**RE: Courtesy Copies of Restoration Schedule Submittal to WDEQ-LQD, Smith Ranch-Highland Uranium Project, License SUA-1548**

**RE: TFN 5 1/119, Non-Significant Revision, Revised Restoration Plan, T2 Review, Cameco Resources, Permit 603**

**TFN 5 1/119, REVISED RESTORATION SCHEDULE, T2 REVIEW  
CAMECO RESOURCES, HIGHLAND URANIUM PROJECT, PERMIT 603**

## TFN 5 3/121, REVISED RESTORATION SCHEDULE, T2 REVIEW CAMECO RESOURCES, HIGHLAND URANIUM PROJECT, PERMIT 633

# Attachment 1 - 2010 HUP Restoration Schedule

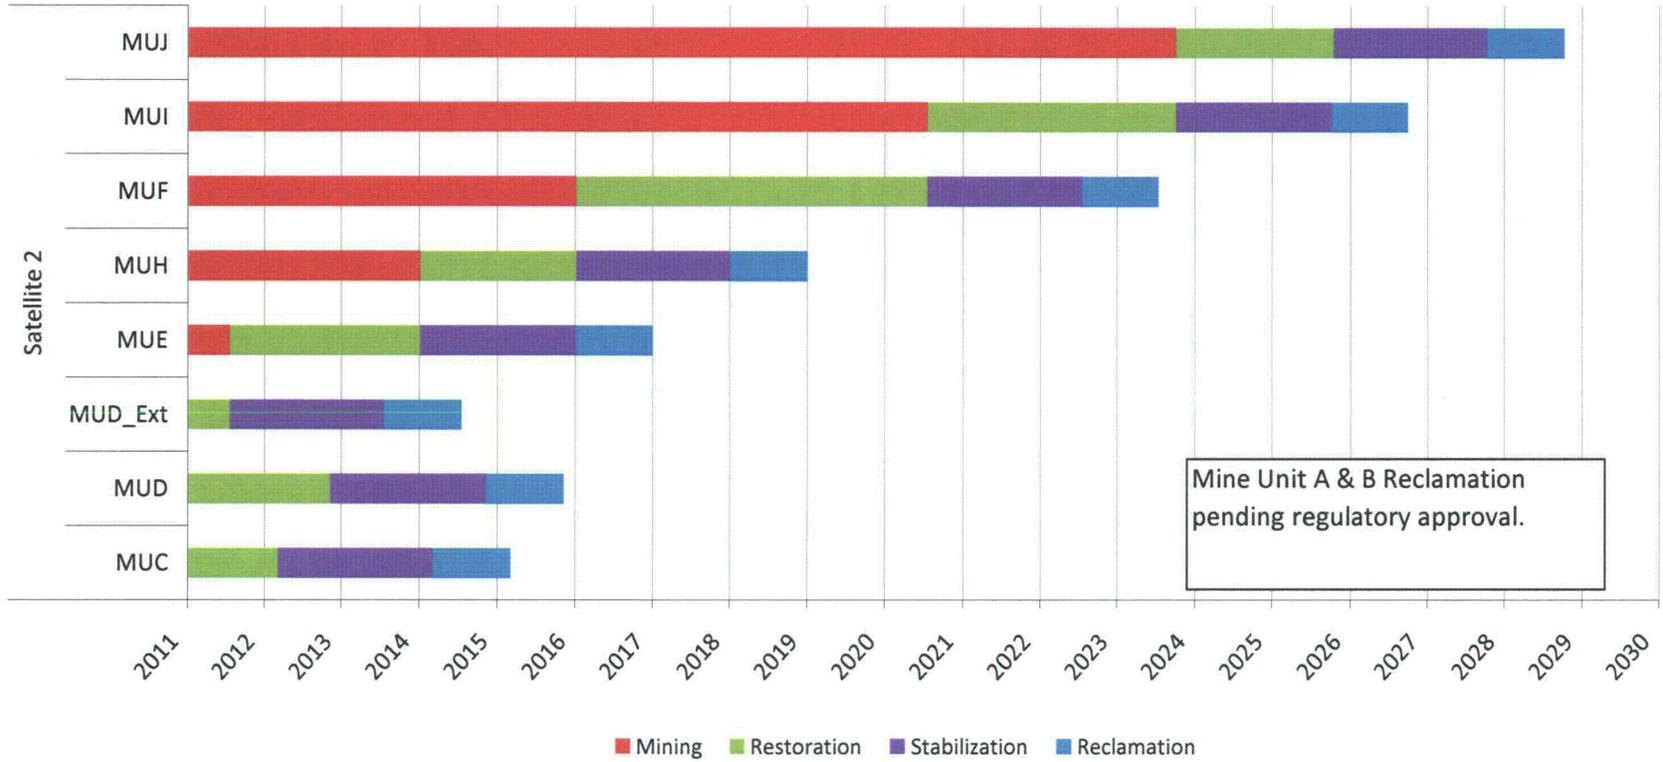
- 3 **Response Not Acceptable.** *The pre-restoration phase needs to have a separate time bar. Please include a pre-restoration time bar on Attachment 1. (SI)*

- 14 *Attachment 1, Restoration Schedule shows a time bar for the addition of bioremediation/chemical reductant. Please include the water usage for this phase in the water balance. (PCR)*

- 20 *Please continue to carry Wellfields A, B and C on the restoration schedule and show the current phase of restoration. The restoration schedule should also show stability monitoring and wellfield reclamation for a clear understanding of the bond required through the life of mine. (PCR)*

**Cameco Response:** The text in the permit has been clarified to discuss restoration planning activities which occurs during the latter part of the mining phase. Cameco wants to expedite restoration by taking care of planning activities such as preparing the mine-unit specific restoration plan, proposing new restoration wells (if required) in coordination with production mining activities. Therefore, Cameco only presents mining, restoration, stabilization, and reclamation as distinct phases in the restoration schedule.

**Cameco Response:** The use of bioremediation and or chemical reductant may be performed concurrently with GWS and or RO; therefore it is not shown as a specific time bar on the schedule. Furthermore, during the bioremediation/chemical reductant addition there is no waste water usage as the chemical reductant is circulated in a closed loop cycle, therefore it is not included in the water balance.

**Cameco Response:** Wellfield C is shown on the revised restoration schedule with a timeline. Wellfields A and B have been illustrated in a text box as these wellfields will be reclaimed pending regulatory approval from the NRC.

ATTACHMENT 3 - 2010 PROJECTED WATER BALANCE  
CONSIDERING 3.0 PV: 1 GWS + 8 RD

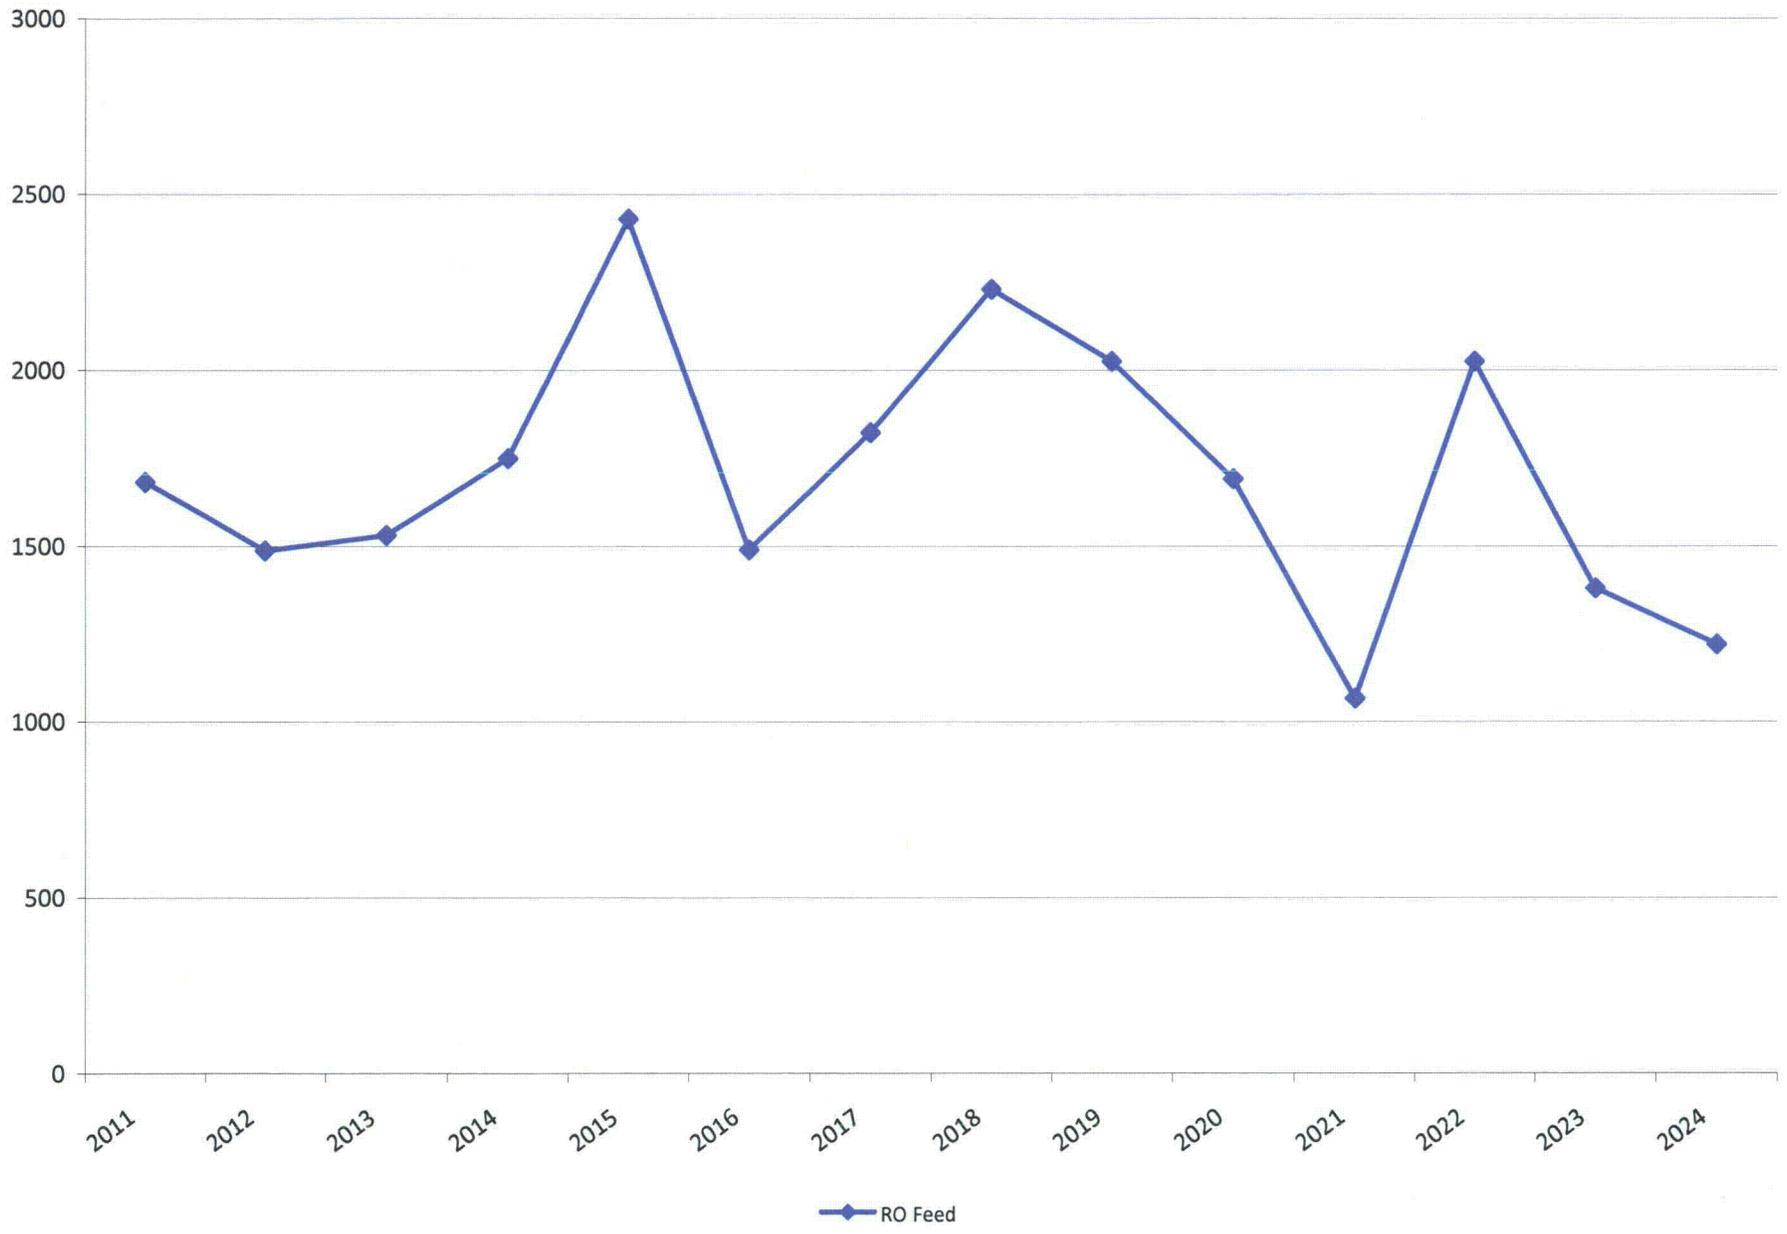
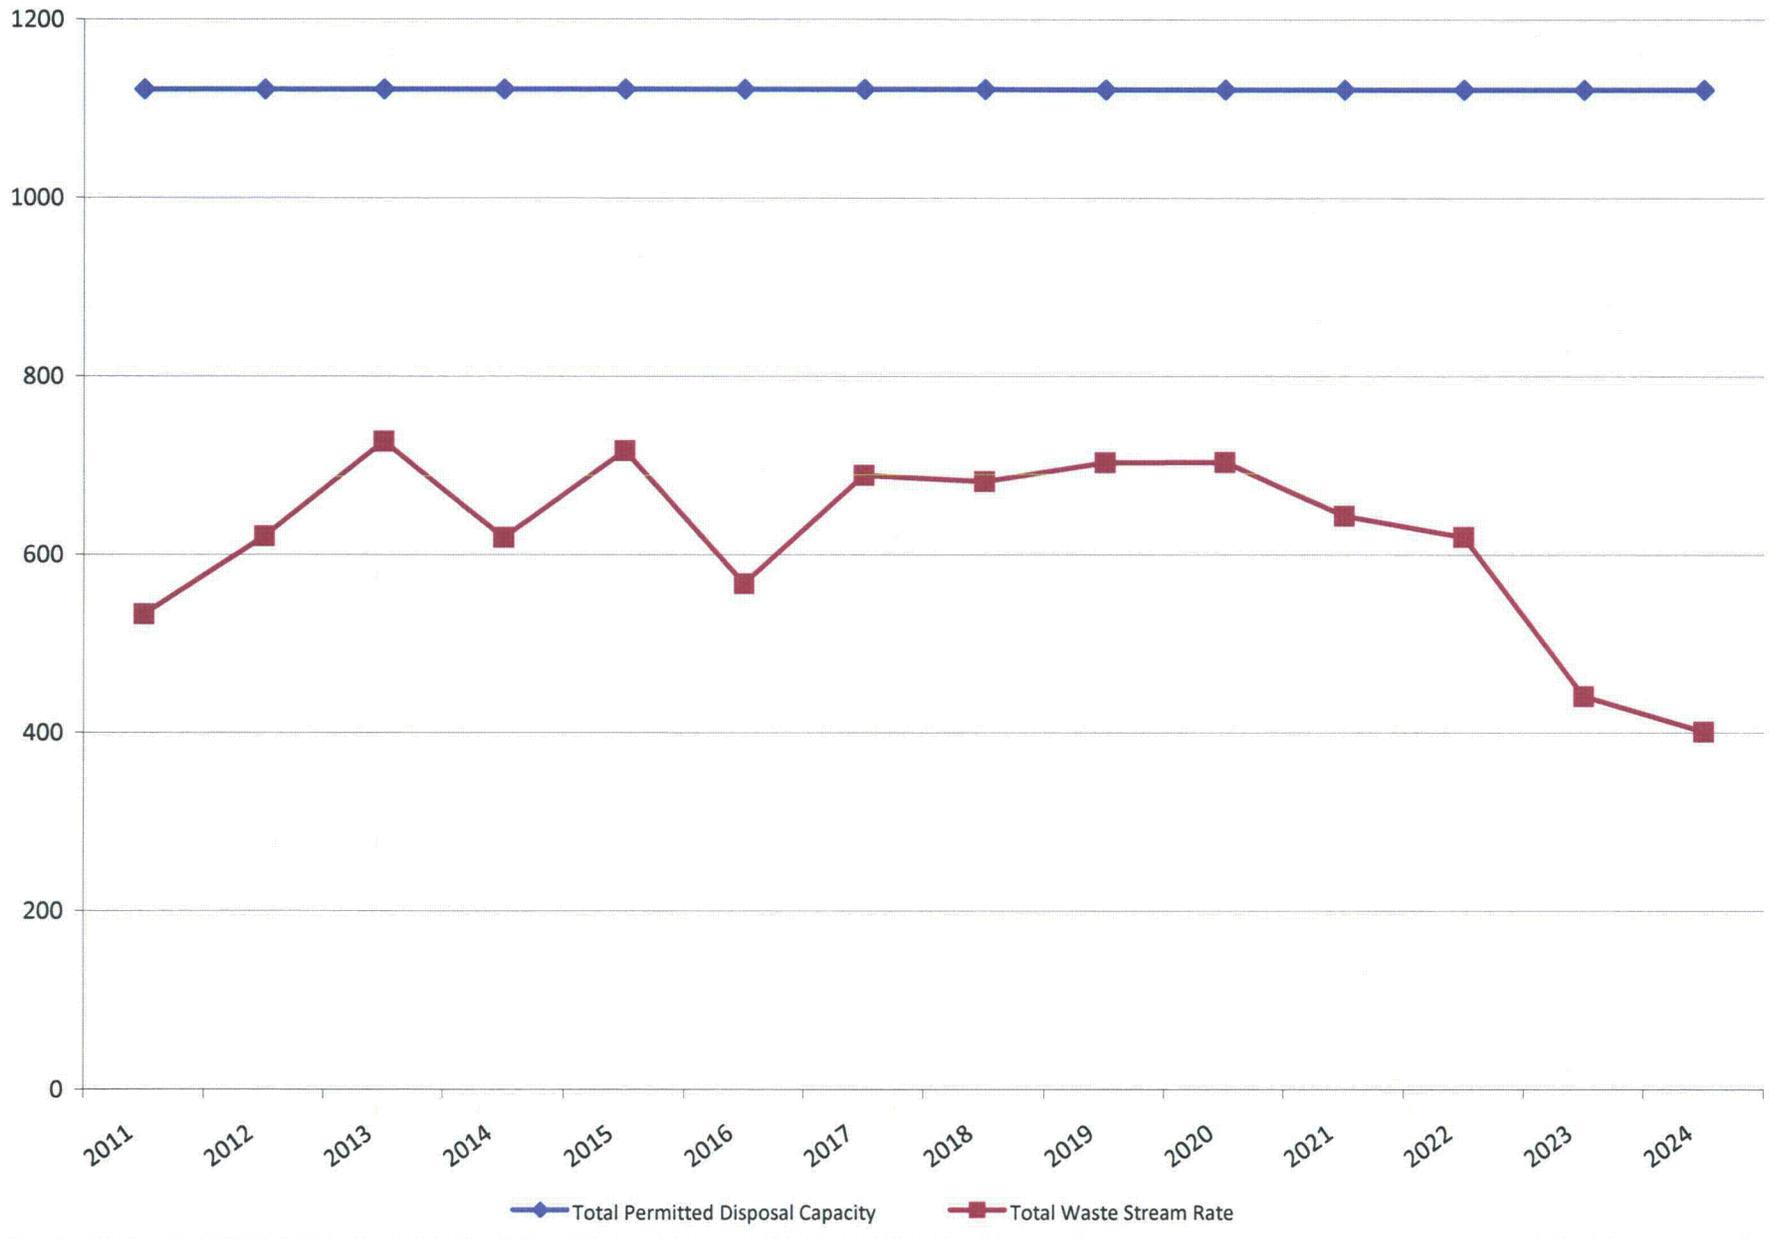
- 4 **Response Not Acceptable.** *The water balance in Attachment 3 only lists RO Reject and Post Production MU Control. Please include groundwater sweep in the water balance. (SI)*

- 9 **Response Not Acceptable.** *The response states that the average monthly inflow to PSR#2 is 180 gallons a minute. The average irrigation rate shown on Attachment 3 for Smith Ranch and Amendment 3 for Highland includes 180 gallons per minute for each permit for a total average application rate of 360 gallons per minute. Please correct the attachments. (SI)*

**Cameco Response:** Cameco has, as stated above, revised the water balance which now includes projected use of groundwater sweep. Please see the attached water balance in this submittal for review.

**Cameco Response:** Please see the revised water balance attached.

# Attachment 1 - 2010 SR Restoration Schedule

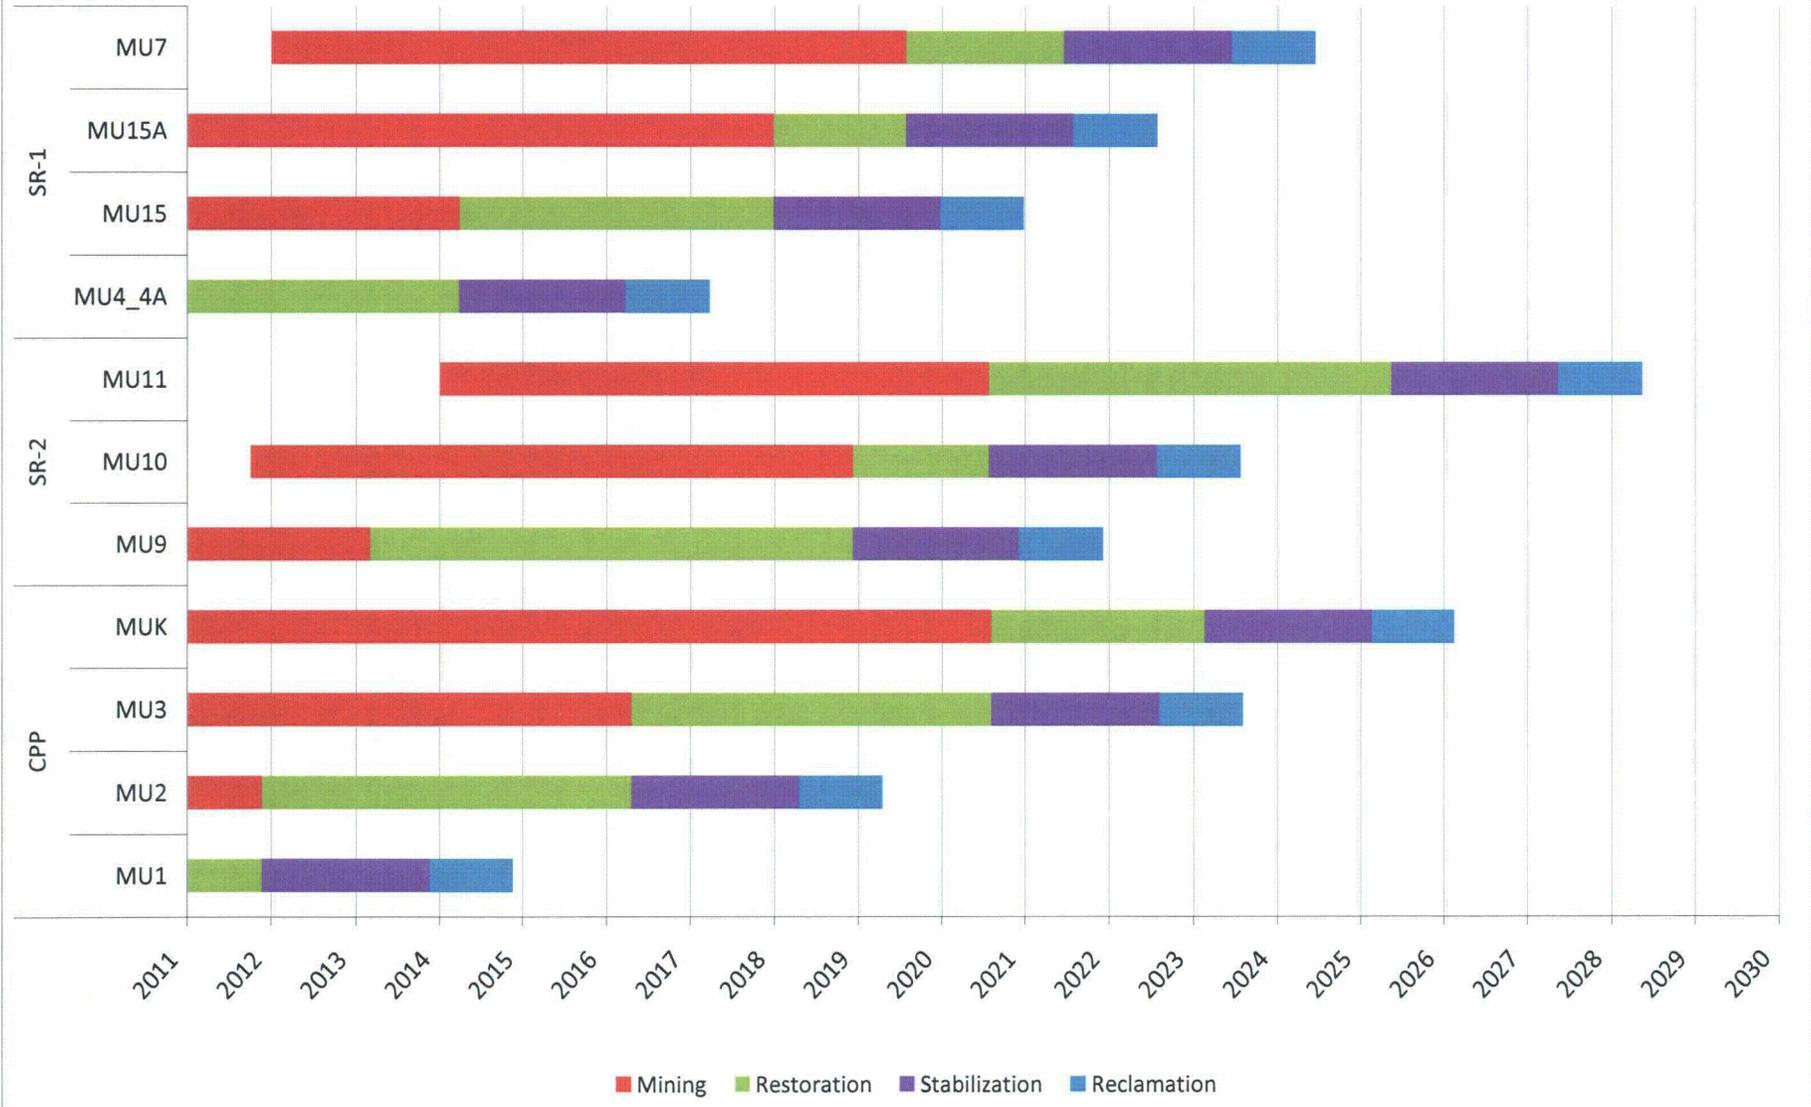
- 3 **Response Not Acceptable.** *The pre-restoration phase needs to have a separate time bar. Please include a pre-restoration time bar on Attachment 1. (SI)*

- 13 *Attachment 1, Restoration Schedule shows a time bar for the addition of bioremediation/chemical reductant. Please include the water usage for this phase in the water balance. (PCR)*

**Cameco Response:** The text in the permit has been clarified to discuss restoration planning activities which occurs during the latter part of the mining phase. Cameco wants to expedite restoration by taking care of planning activities such as preparing the mine-unit specific restoration plan, proposing new restoration wells (if required) in coordination with production mining activities. Therefore, Cameco only presents mining, restoration, stabilization, and reclamation as distinct phases in the restoration schedule.

**Cameco Response:** The use of bioremediation and or chemical reductant may be performed concurrently with GWS and or RO; therefore it is not shown as a specific time bar on the schedule. Furthermore, during the bioremediation/chemical reductant addition there is no waste water usage as the chemical reductant is circulated in a closed loop cycle, therefore it is not included in the water balance.

### DDW Permitted Capacity vs Projected Disposal

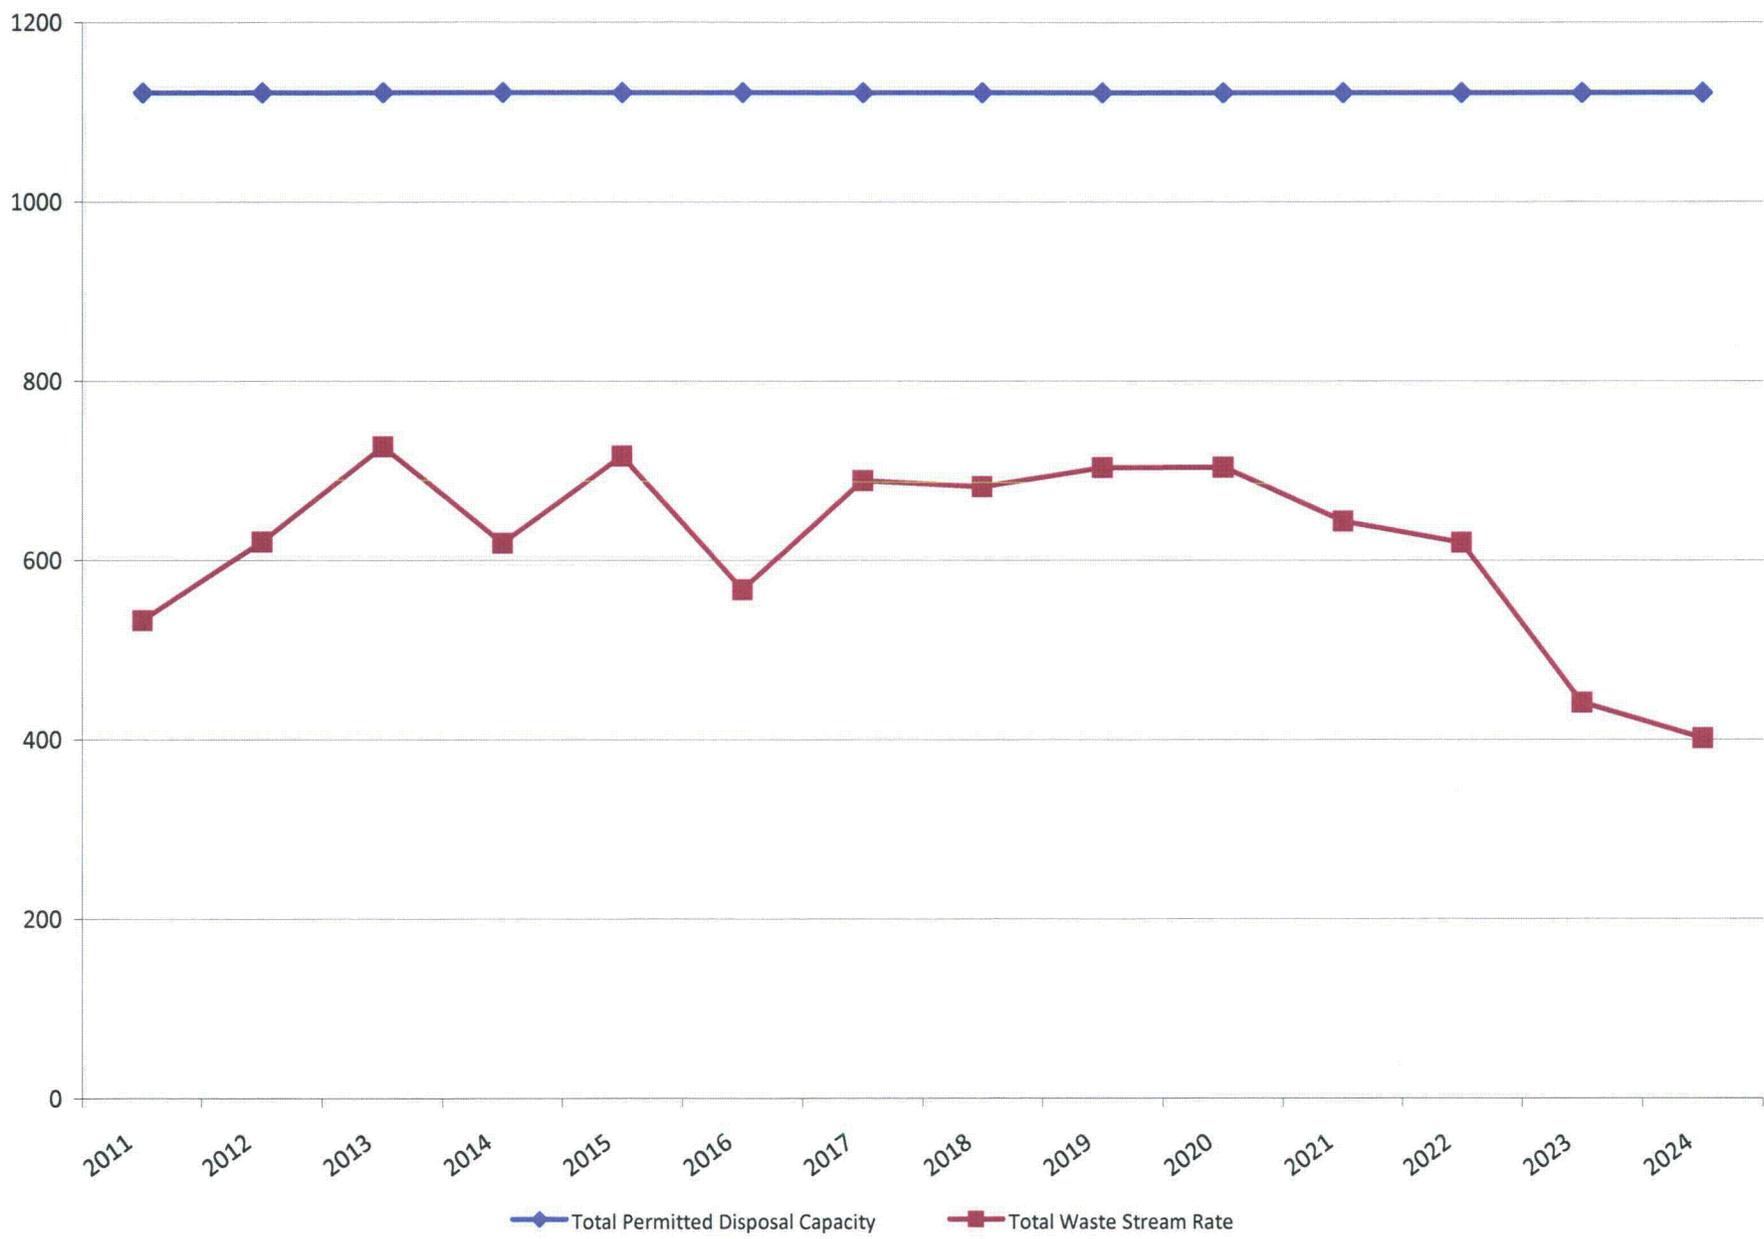
- 4 **Response Not Acceptable.** *The water balance in Attachment 3 only lists RO Reject and Post Production MU Control. Please include groundwater sweep in the water balance. (SI)*

- 14 *Attachment 3, 2010 Projected Water Balance. The water balance and restoration schedule are based on updated estimated calculations submitted in September of 2010. The original schedule was proposed in August 2009. LQD continues to have comments which will likely require further changes to the schedule (i.e., groundwater sweep estimates and reductant estimates). In addition, the disposal capacity is incorrect due to delays in completion of new disposal wells. Other changes such as Mine Unit E schedule for groundwater sweep is in question in lieu of the proposal to mine in a different zone. The schedule should be as current as possible for approval. Please revise the schedule to accurately reflect the 2010 water balance. (PCR)*

**Cameco Response:** Cameco has, as stated above, revised the water balance which now includes projected use of groundwater sweep. Please see the attached water balance in this submittal for review.

**Cameco Response:** Cameco has attached the revised restoration schedule and water balance to this submittal. Cameco met with LQD on April 13, 2011 to present and discuss each.
